ADDENDUM 1 – JOB 23645

TO: All prospective bidders on Project HEU-1-981(134), Job No. 23645 scheduled for the November 14, 2025 bid opening.

PLAN ADDENDUM SUMMARY AND APPROVAL

PROJECT INFORMATION		
Date: 11/4/2025	Project: HEU-1-981(134)	PCN: 23645
Lead Designer: Aaron Schmidt	Technical Support: Seng Marohl	
Bid Opening Date: 11/14/2025	Job Number: 23645	Addendum Number: 1

Bismarck ENGINEERING
CENTURY AVENUE
PAVING LAYOUTS
STA 22+00 - 26+50

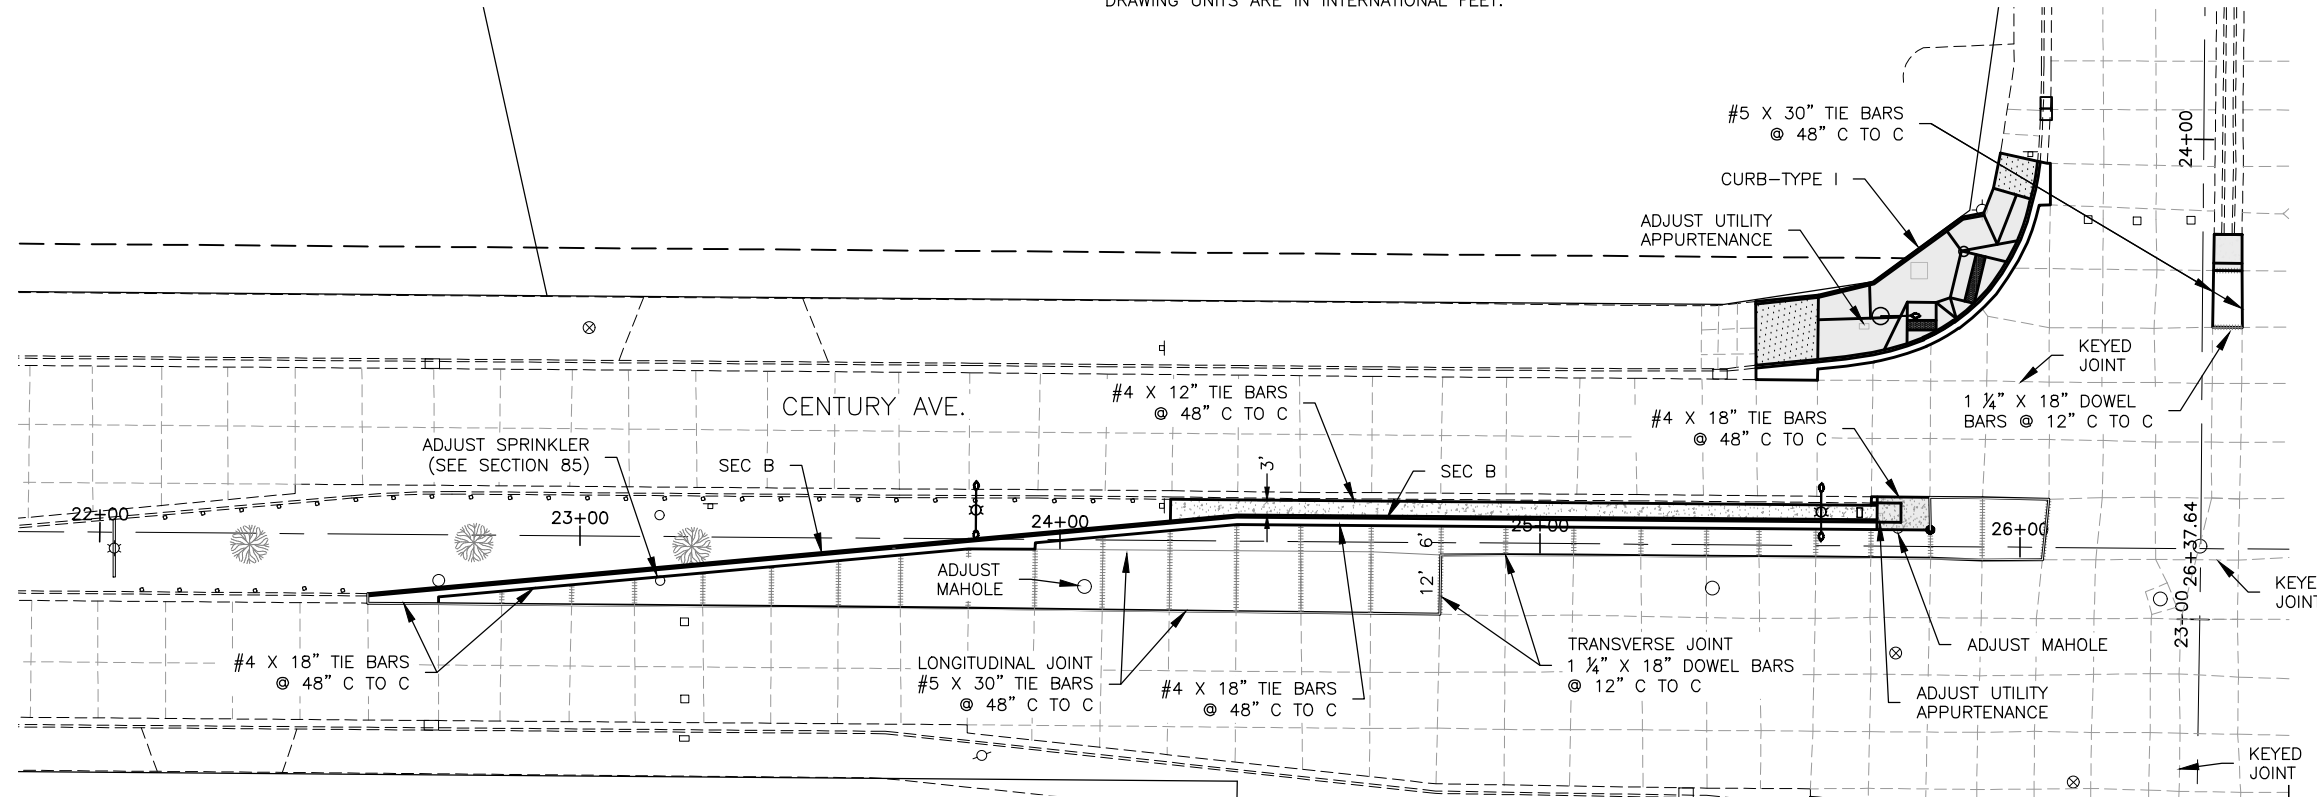
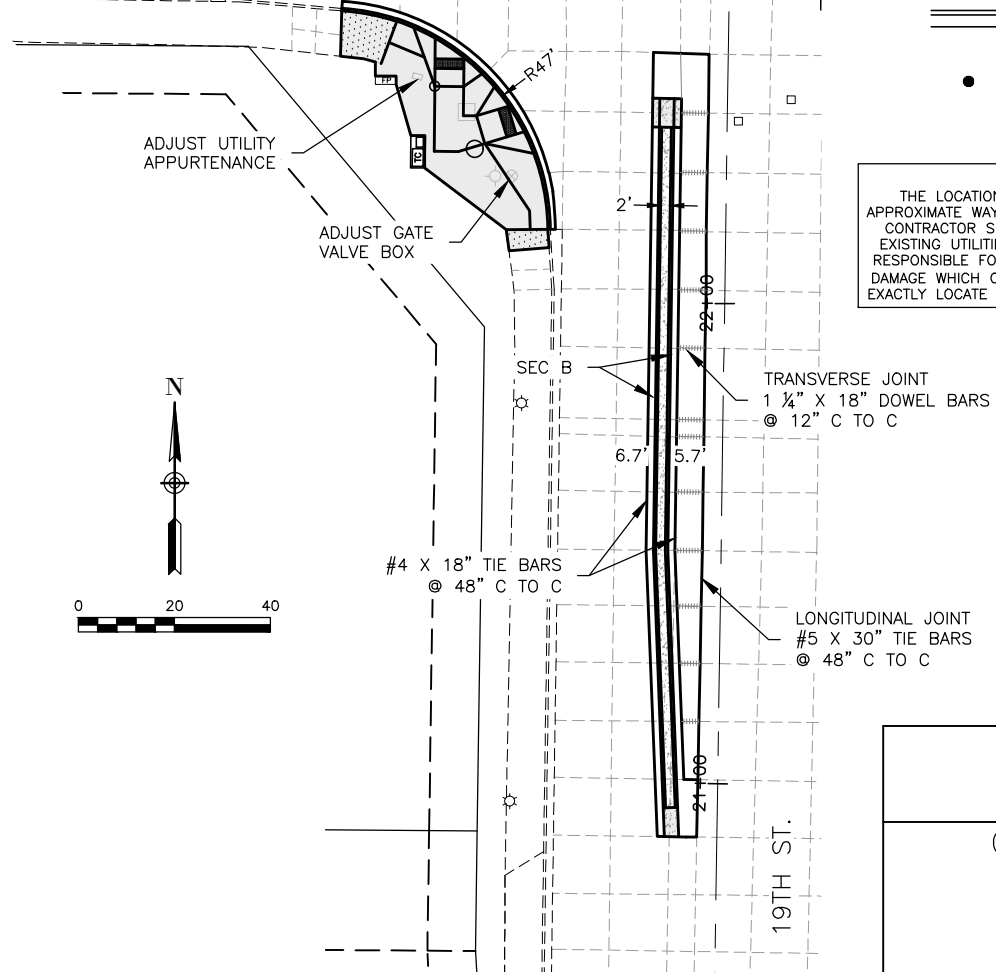
90	1-2	Revised sheet quantities for bid items: <ul style="list-style-type: none"> • 302 0120 AGGREGATE BASE COURSE CL 5 • 709 0151 GEOSYNTHETIC MATERIAL TYPE R1 Included bollard coordination note on plan view
